Proposed Hydro-electric Generating Station at the Bala Falls

Requested shoulder widening: Show us the whole plan

SaveTheBalaFalls.com 2015 03 12

Planned building height

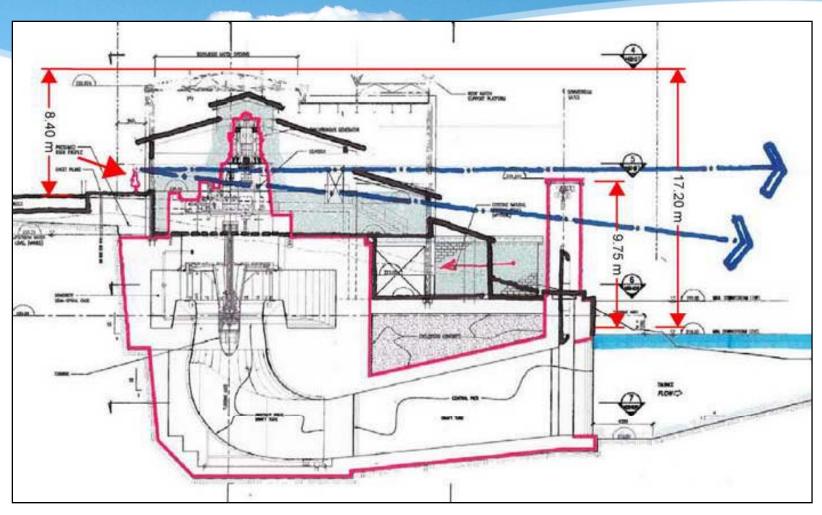
- The proponent's 2005 proposal stated the roof of their building would be below the level of Muskoka Road 169
- The proponent's 2012
 Addendum showed even with a vertical turbine the building would be about 30' high, and below road level

But their engineering drawings show it would be 28' above the road and 56' above the Moon River

2012 Addendum

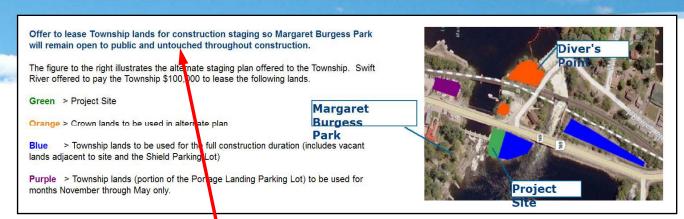
- Proponent's 2012 Environmental Screening/Review
 Report Addendum
 - Section 2.1 said footprint presented is "the largest building size required ... this size may indeed be reduced ..."
 - ► Yet later drawings show it would actually be 48% larger, filling the entire 70' x 100' site with concrete
 - Section 4.6.1 said Alternative 1A proposal would "not impact"
 Portage Landing
 - ➤ Yet now they've requested to cut down all the trees on it, and pile it full of blasted rock

Margaret Burgess Park

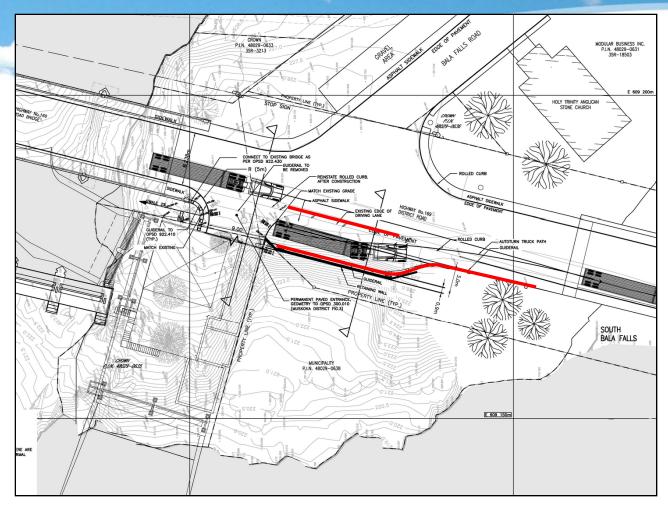
- Proponent's web site now says if they can use three
 Township properties: "Margaret Burgess Park will remain open to public and untouched throughout construction"
 - Yet now their February 26, 2015 document apparently says they would only "would reduce the requirements of storage in Margaret Burgess Park"
- Proponent has a self-serving history of telling people what they want to hear
 - Then reneging

Requested shoulder widening

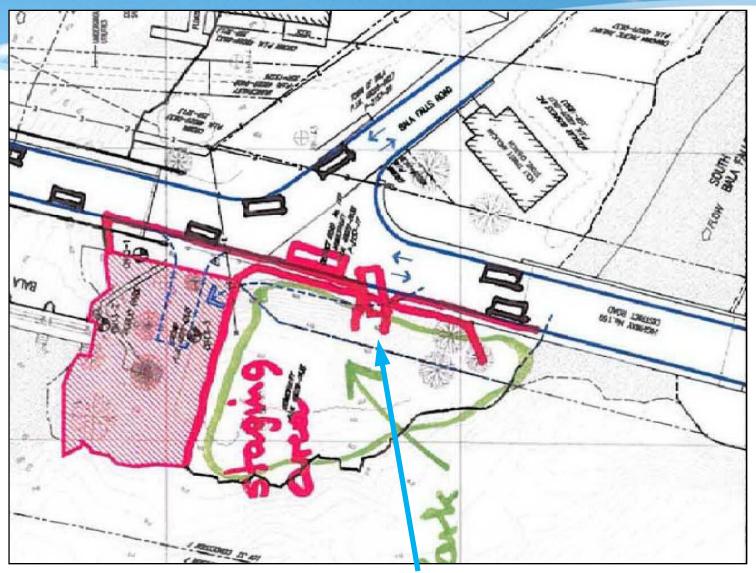
- Last year proponent said it would need one guardrail
 - This year they say it would be two rows of Jersey Barriers

- Ontario's Roadside Safety
 Manual requires that barriers
 have "end treatments"
 - These are often wide or curved

Portage Landing driveway request

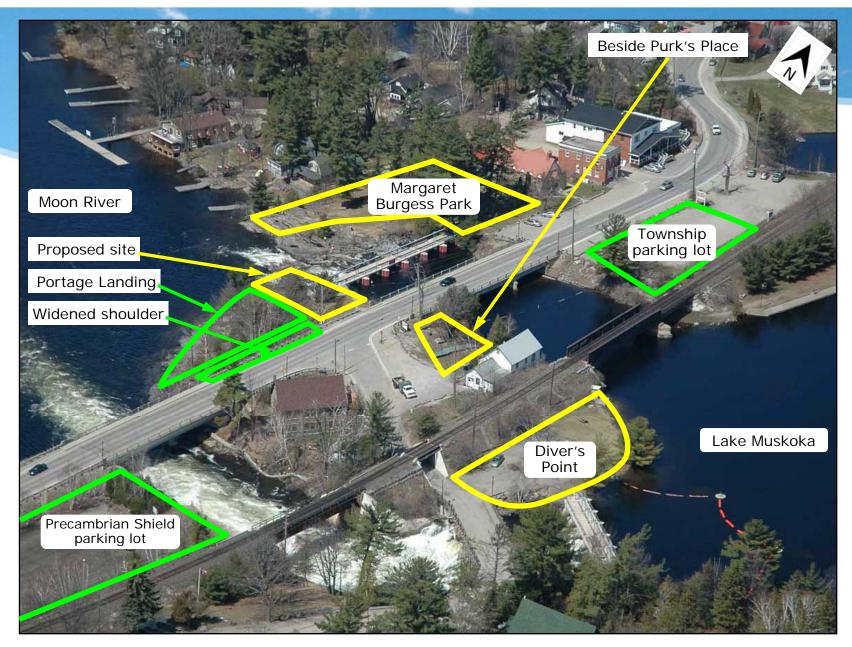
Would need a dangerous opening in guardrail
